City of Bristol
Conservation Commission/ Inland Wetlands and Watercourses Agency

SPECIAL MEETING - WEDNESDAY, MAY 22, 2024
CITY HALL COUNCIL CHAMBERS
111 NORTH MAIN STREET
7:00 P.M.

- b. Application #2020 – Wetlands application for the restoration of the White Bridge Waterworks facility at Maltby Street; Assessor's Map 52 & 53, Lots 11, 15, 16B16A, 17, 145, 147, 149, 150 & 151; New Britain Water Department, Ramon Esponda, Deputy Director, applicant (Public Hearing Closed at May 6, 2024 Regular Meeting).

**BRISTOL CONSERVATION COMMISSION
INLAND WETLANDS AGENCY
FORM IW-2 (Application for a Wetlands Boundary Change)**

4. Drawing: C-23

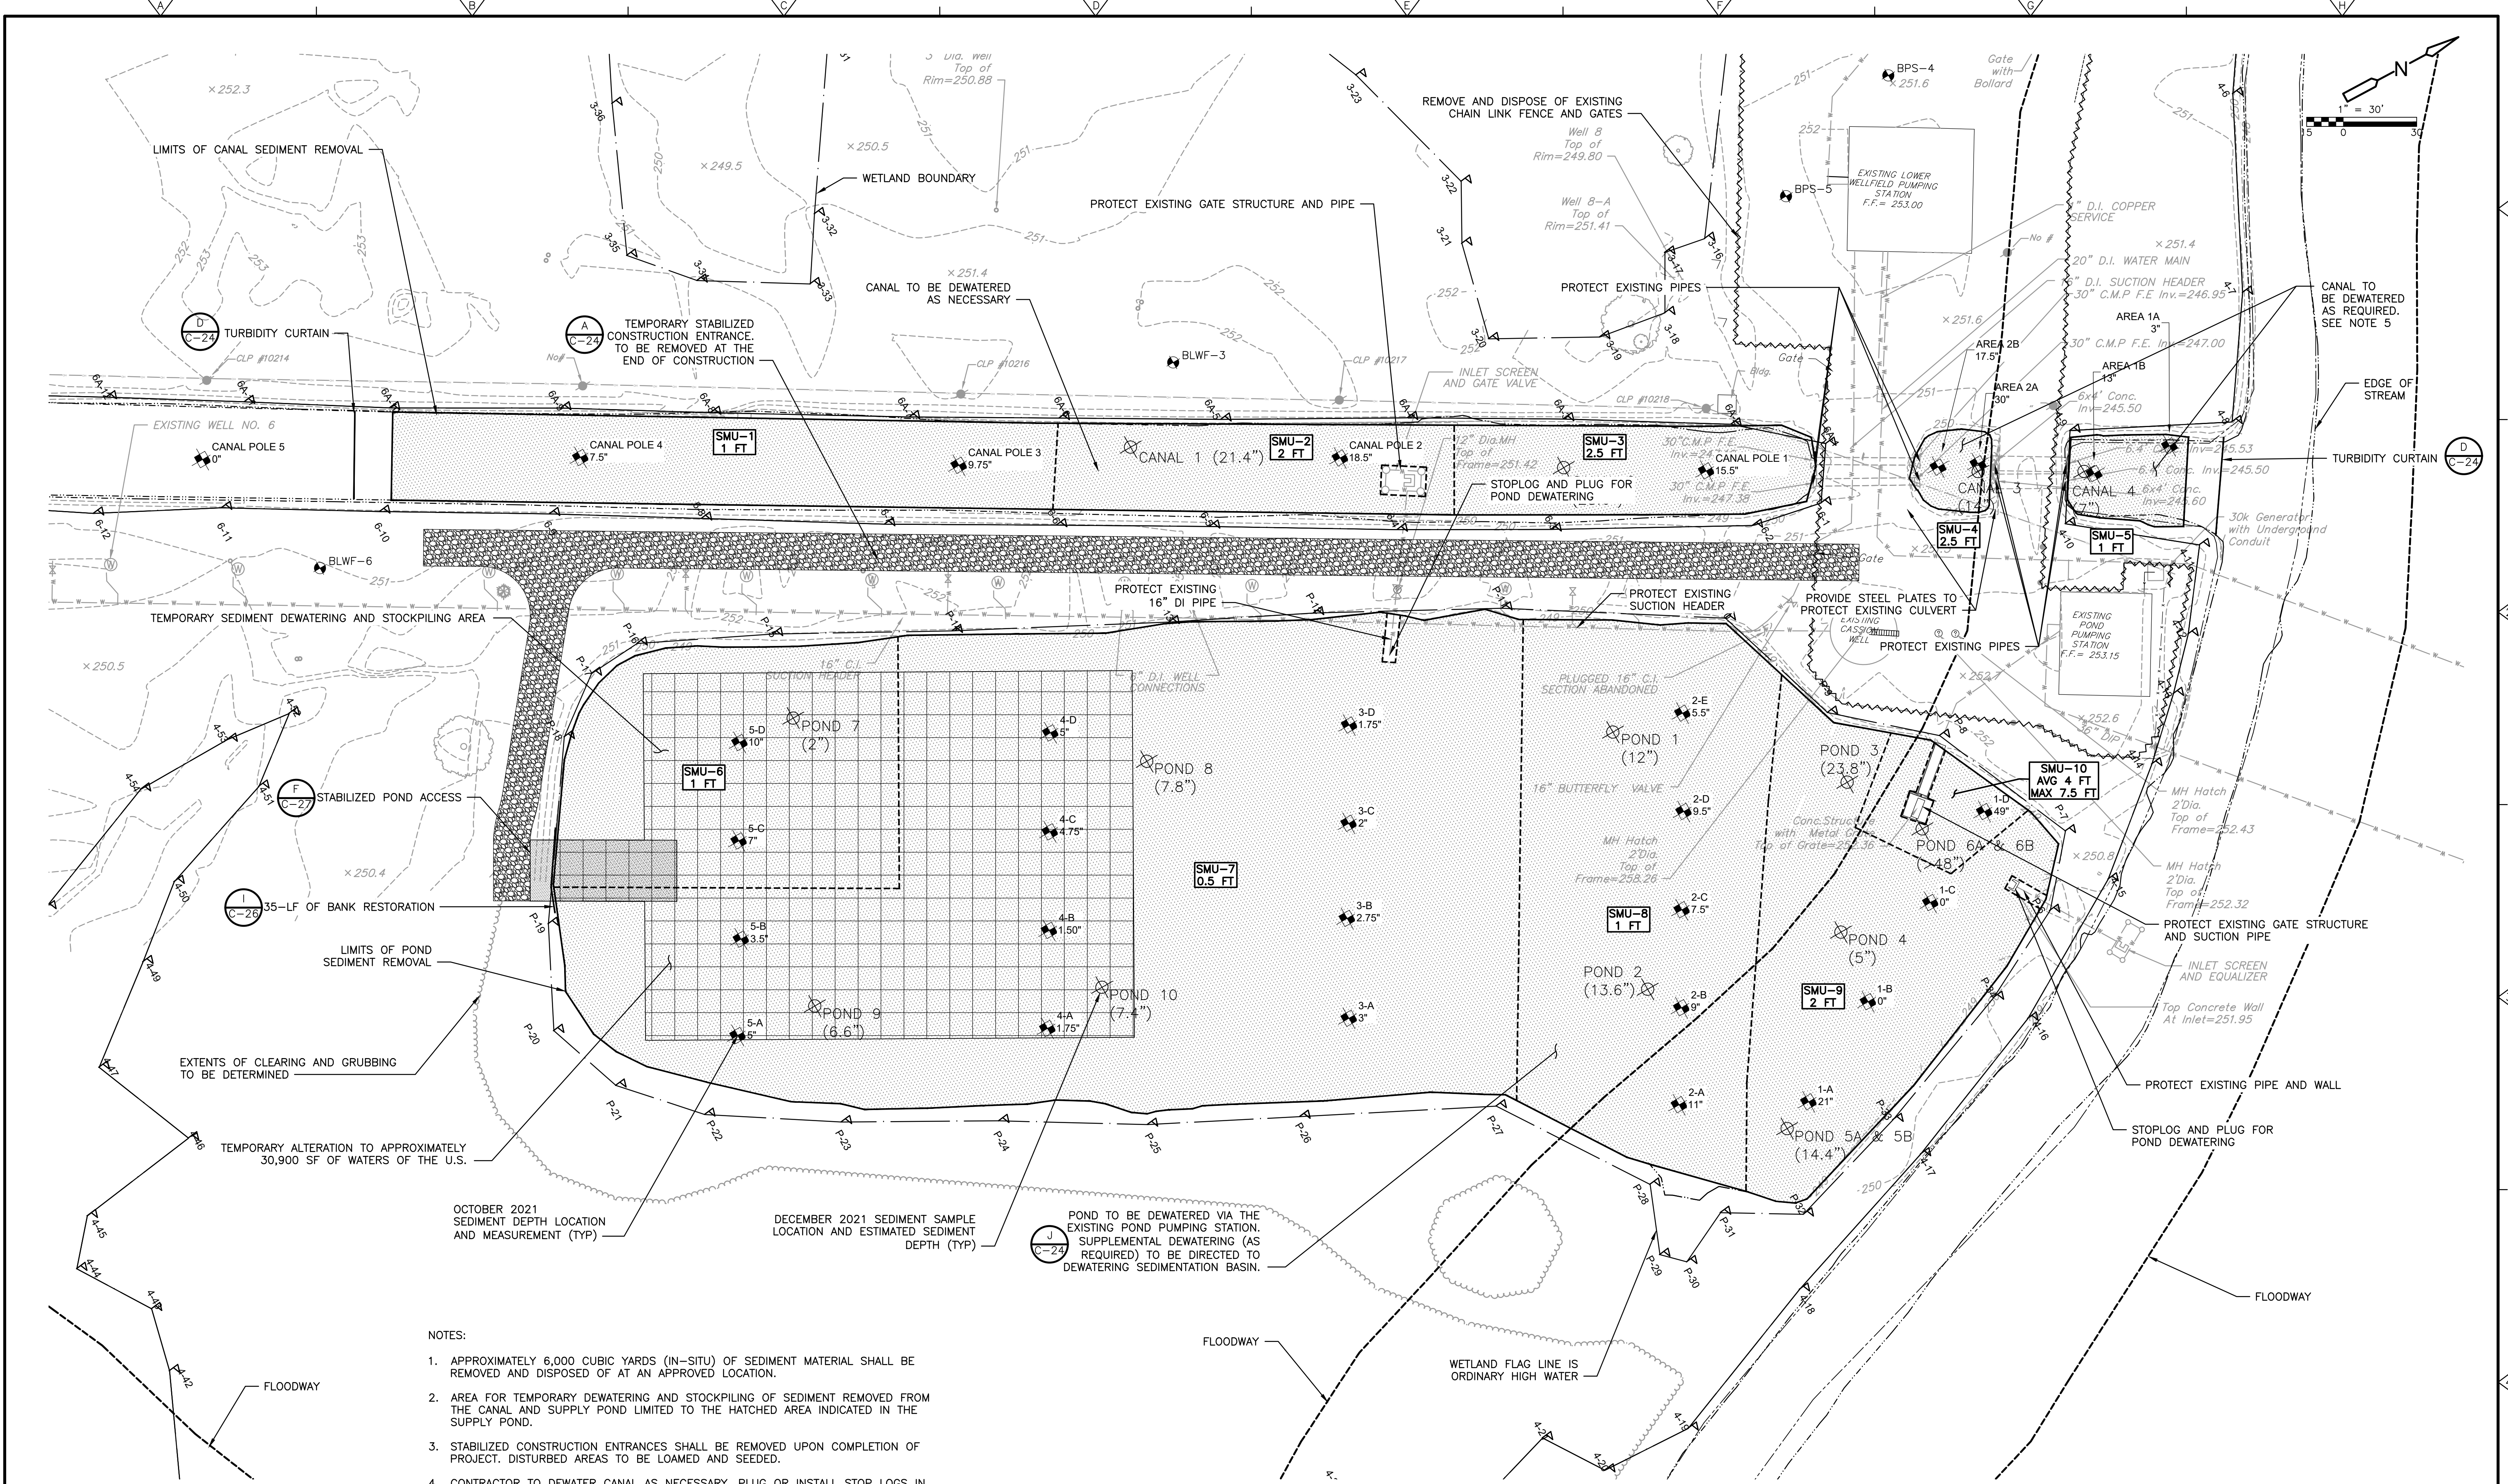
4/22/24 Applicant Response: Floating turbidity curtains are to be located within the canal, east and west of the proposed sediment removal areas. See revised Sheet C-23 in Attachment 4.

Project No.: 702	Sheet WR-2
Date: 12/1/2022	
Drawn By: NP	
Checked By: SA	
Scale: AS SHOWN

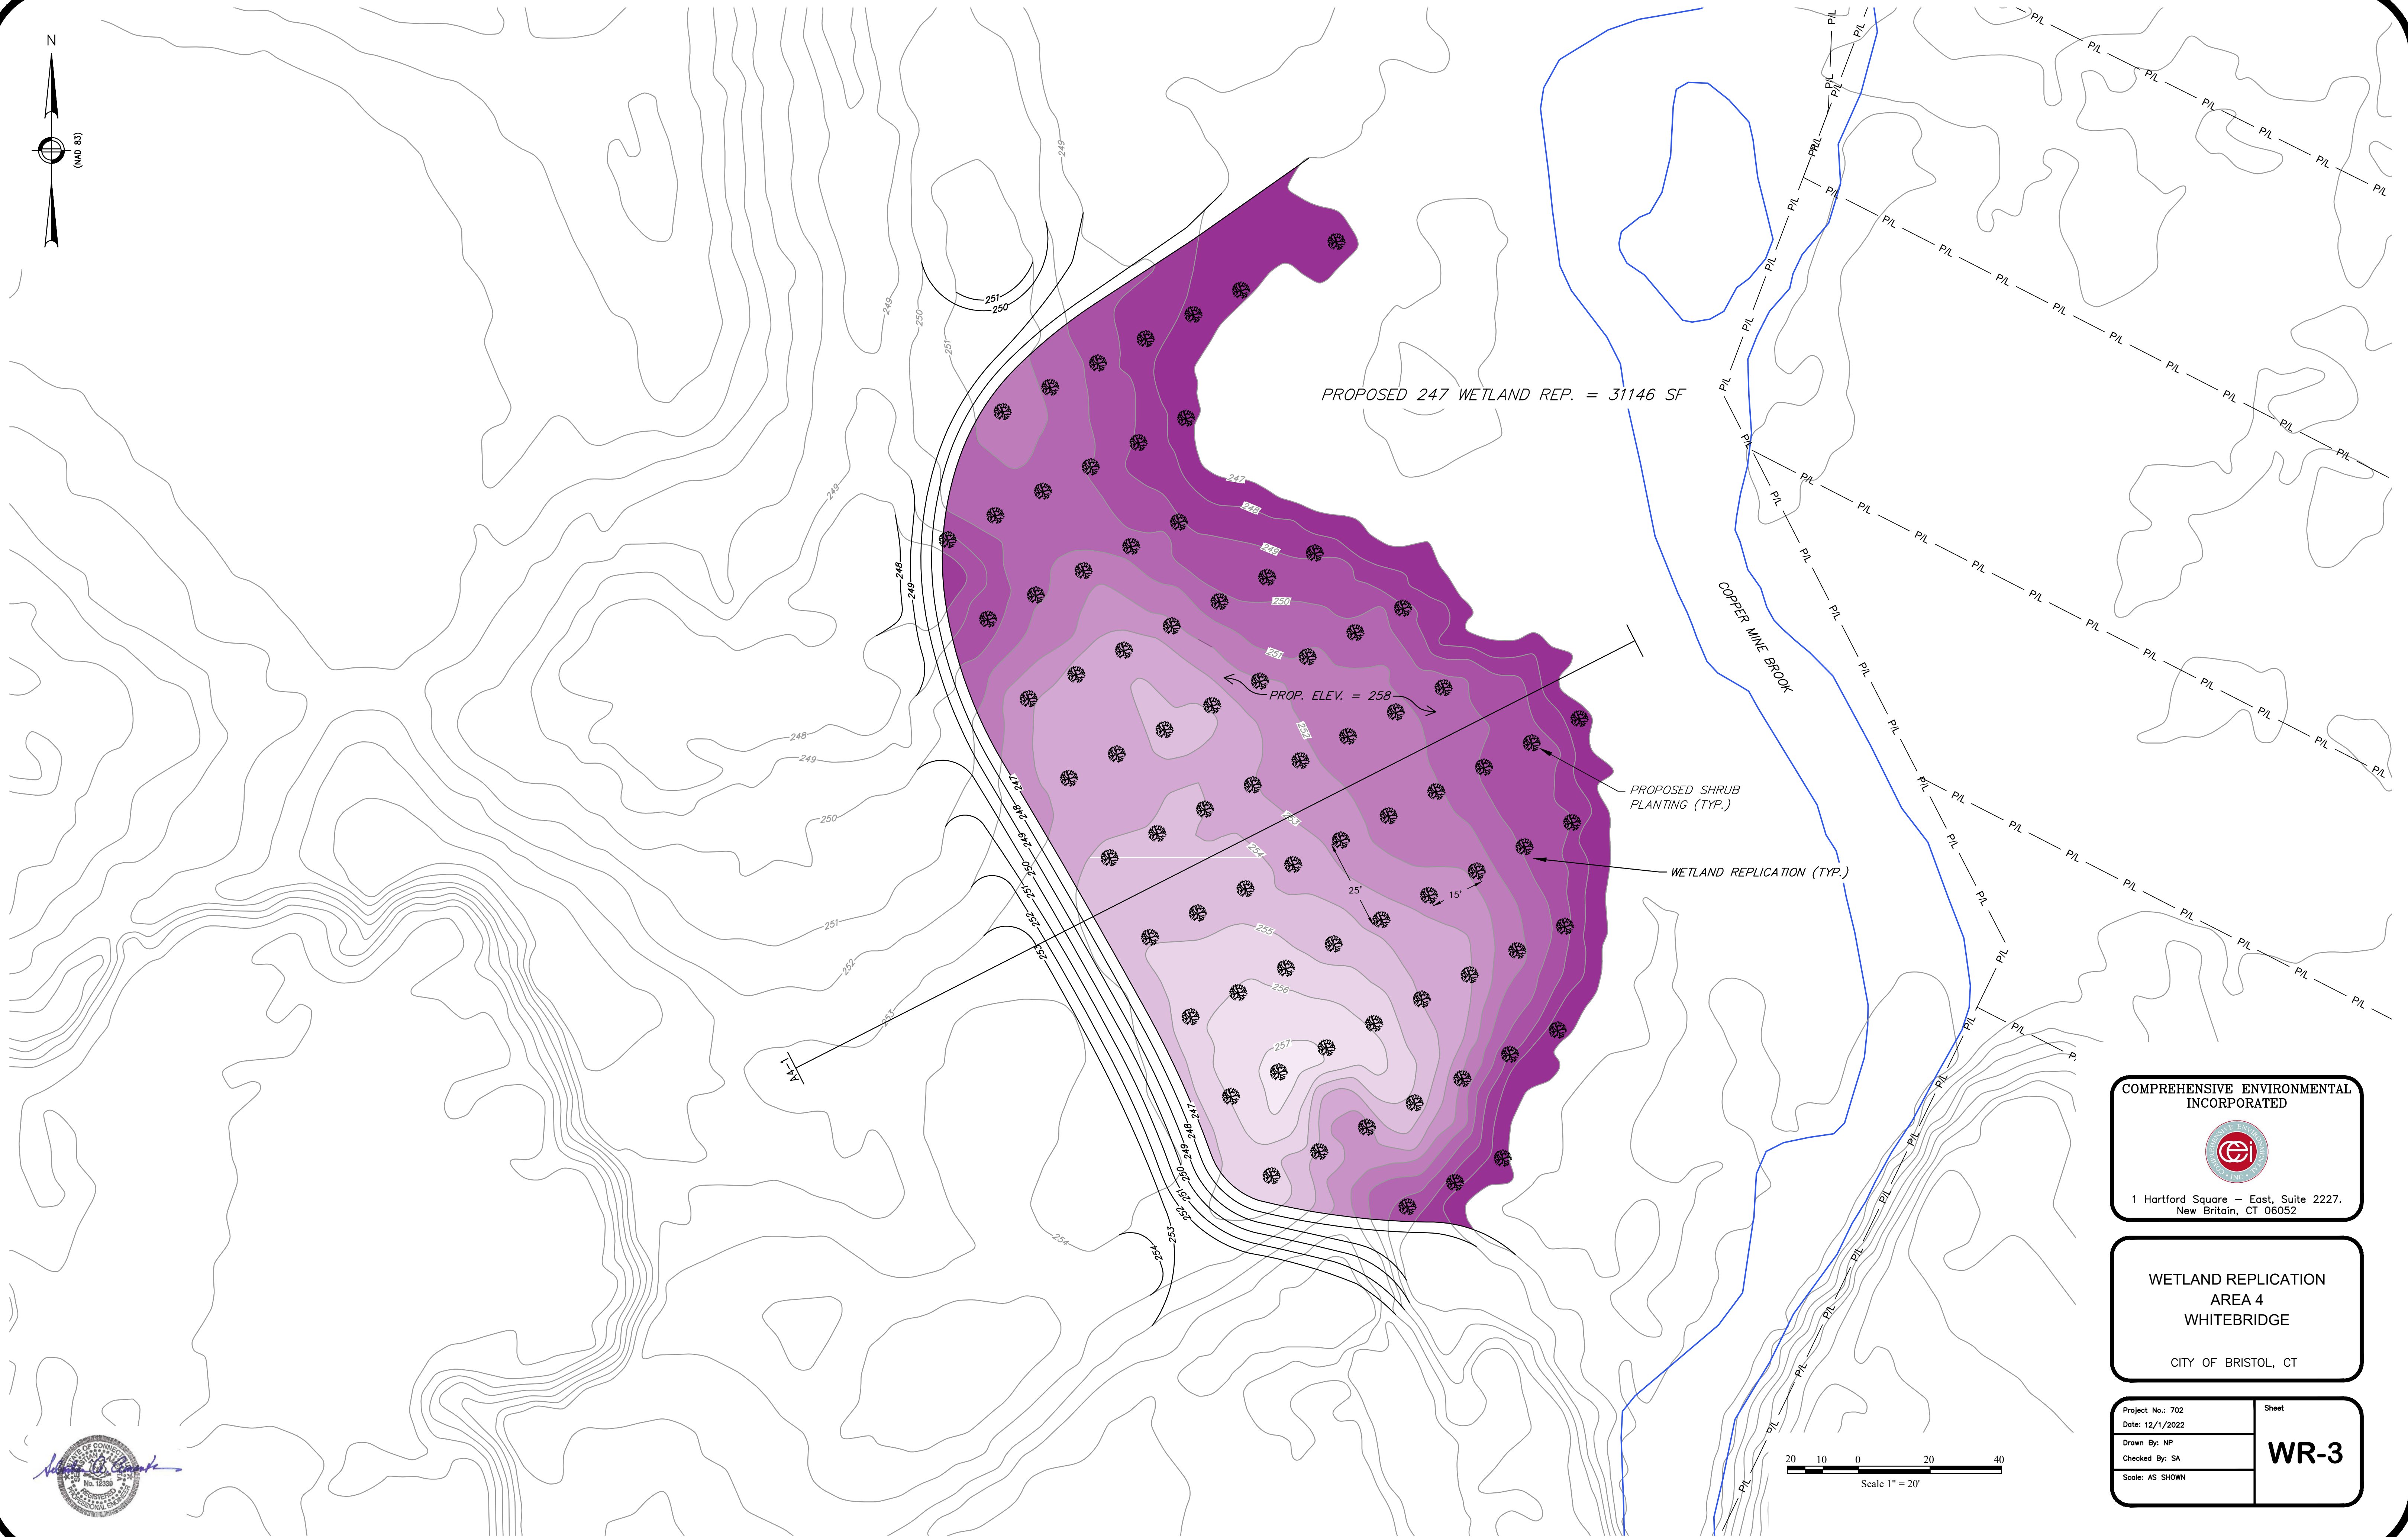
- b. On sheet WR-2, will any grading and stabilization be done for the haul/construction/access road? (The south road shows “dips” of 3’ - 4’ in the vicinity of the road narrowing for the south longitudinal section of mitigation). What is the tabulated area of impact for wetlands/upland review for these areas, including slope transitions, with a discussion of the existing land cover? Please discuss periods for invasive management and any proposed chemical use that may be needed to manage invasives in these proposed mitigation area. Due to the proximity of the wells, will chemical use be restricted? The plan calls for wetland replication of 3,057 SF to el 257 and 2,008 SF to el 256. The third area of impact/replication is not called out. What is the quantity of temporary impacts in regulated wetlands for each area’s construction? What is the anticipated surface water fluctuation to the adjacent wetlands and brook resulting from the new wells?
